SP-2018-00016:

Ecovillage Steep Slopes ("Private Facilities")

Board of Supervisors Public Hearing May 1, 2019

C7 OF 8

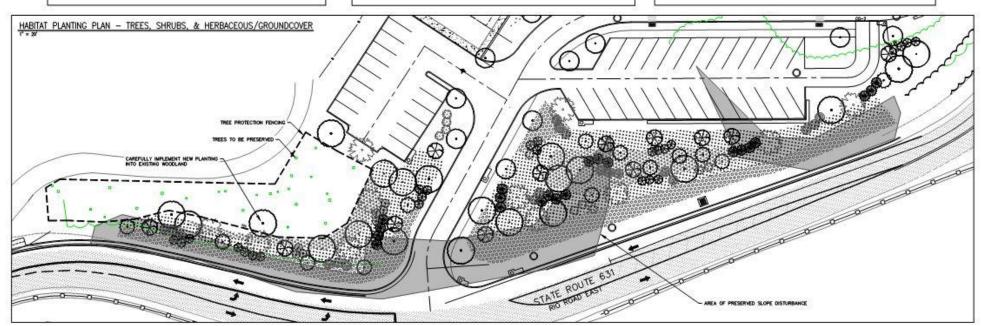
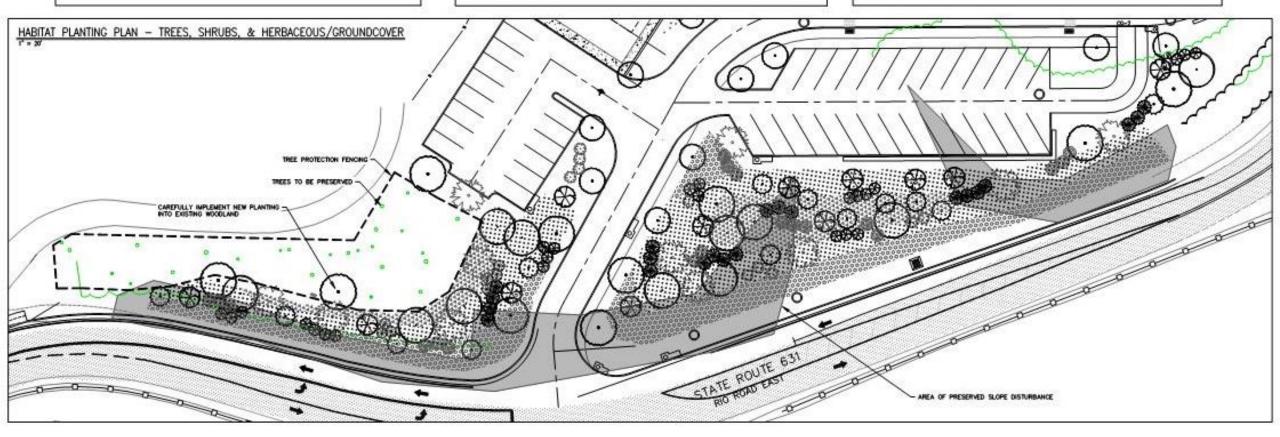
- a. The "Landscape Schedule" for the "Habitat Planting Plan" must be revised so that a certain portion (25% 33%) of the tree plant materials and shrub plant materials are specified at a minimum caliper or minimum height that, at the time of planting, meets the minimum size requirements for landscaping materials as would be required within the Entrance Corridor.

- b. The "Habitat Planting Plan" must be revised to be supplemented with additional numbers of evergreen shrubs and evergreen trees at strategic locations in the vicinity of the proposed parking area private facility in order to sufficiently provide screening for this proposed private facility within the preserved steep slopes overlay district. A certain portion (33% 66%) of these vegetative screening materials in this vicinity shall be specified at a minimum caliper or minimum height that, at the time of planting, meets the minimum size requirements for landscaping materials as would be required within the Entrance Corridor.
